**FIVE-YEAR REVIEW
FINAL REPORT**

**POWERSVILLE LANDFILL SITE
POWERSVILLE, PEACH COUNTY, GEORGIA**

DECEMBER 1997

SITE SKETCH

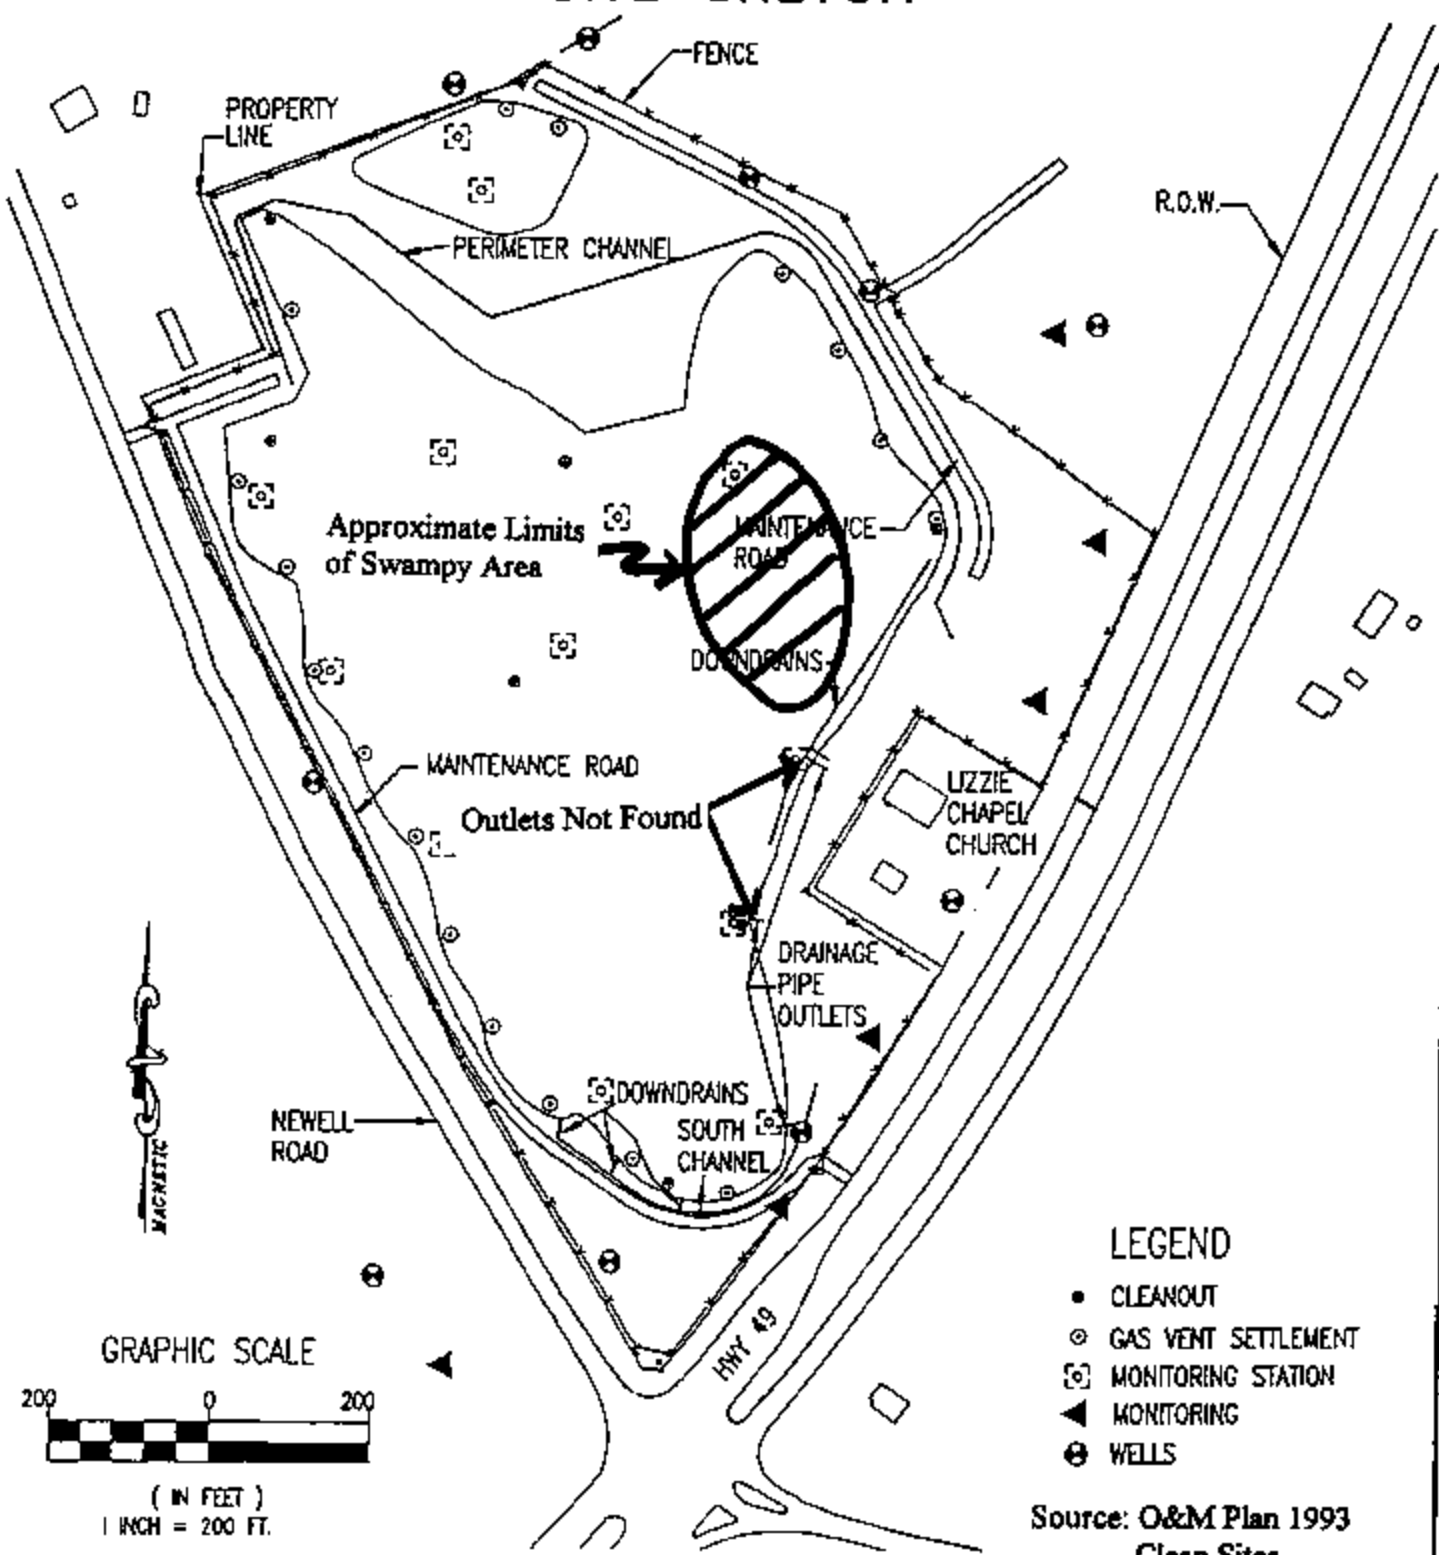
The last feature of the landfill observed during the site reconnaissance was the subsurface drainage pipe outlets (Photograph No. 13). According to the O&M Plan and, as shown on Figure

2-1, three of these are supposed to exist along the south and east sides of the landfill. Only one of these was found by WESTON. The other two are apparently covered or have settled into the cover soil. The function of these outlets are to provide a positive outlet from the cover drainage layer. WESTON observed a swampy area shown on Figure 2-1, which is in a relatively flat portion of the landfill. This could be a result of settlement and/or plugging of the remaining two pipe outlets in the vicinity. The negative effects of this swampy or ponded area is documented in Section 4.2.1 (Page 4-14) of the Operations and Maintenance Plan, August 19, 1993, as follows:

A swampy condition on the relatively flat portion of the cover exists on the east side. This could be caused by non-functioning drainage layer pipe outlets.

The drainage layer pipe outlets should be investigated to determine the location and potential link to the swampy area as shown on Figure 2-1. If the outlets are plugged due to settlement, repairs should be performed in accordance with Section 15.6.3 of the Operation and Maintenance Manual, August 19, 1993, prepared by CSES.

Photograph No. 3

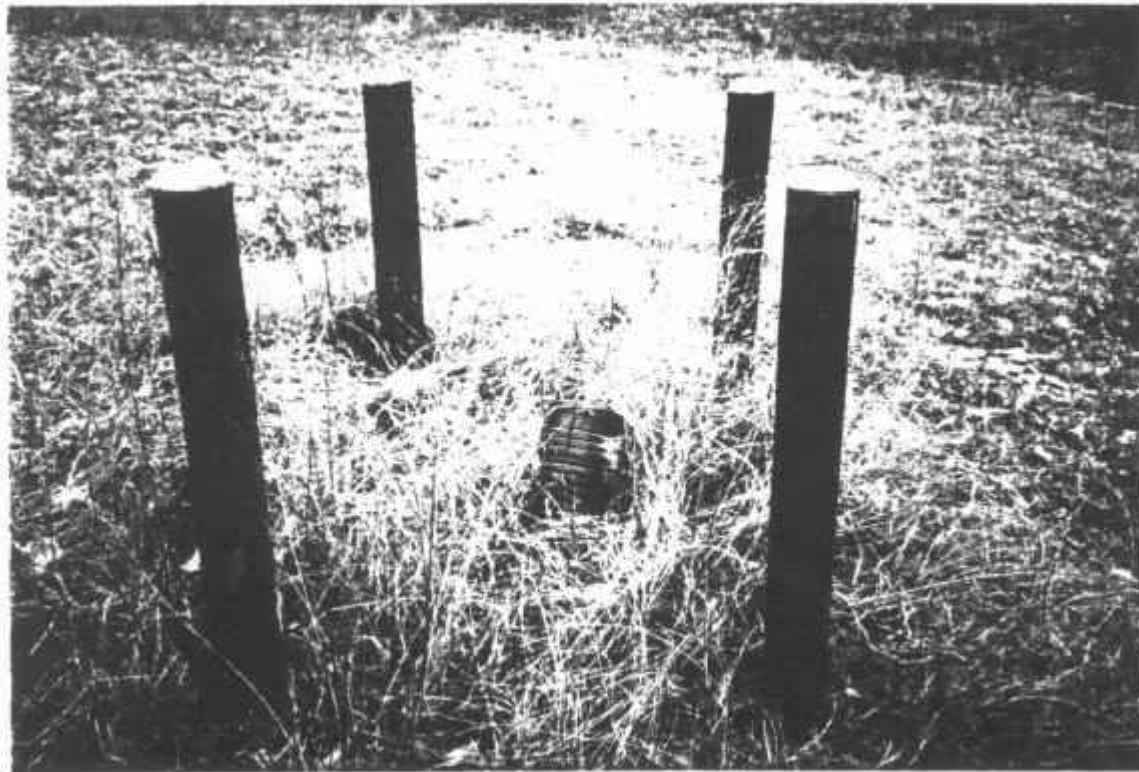
Looking over the entire site from the entrance gate (Photograph No. 2), the cover system appears to be well maintained. Walking along the perimeter just inside the fence line, some unvegetated

areas with minor erosion was observed (Photograph No. 3). This can only be corrected by reseeding the bare areas to establish a continuous vegetative cover.

The small bare soil areas require reseeding to establish permanent vegetation for erosion protection on the cover system. Consultation with the local National Resource Conservation Service of the U.S. Department of Agriculture is recommended to obtain the proper application rates and fertilization requirements best suited for the local conditions.
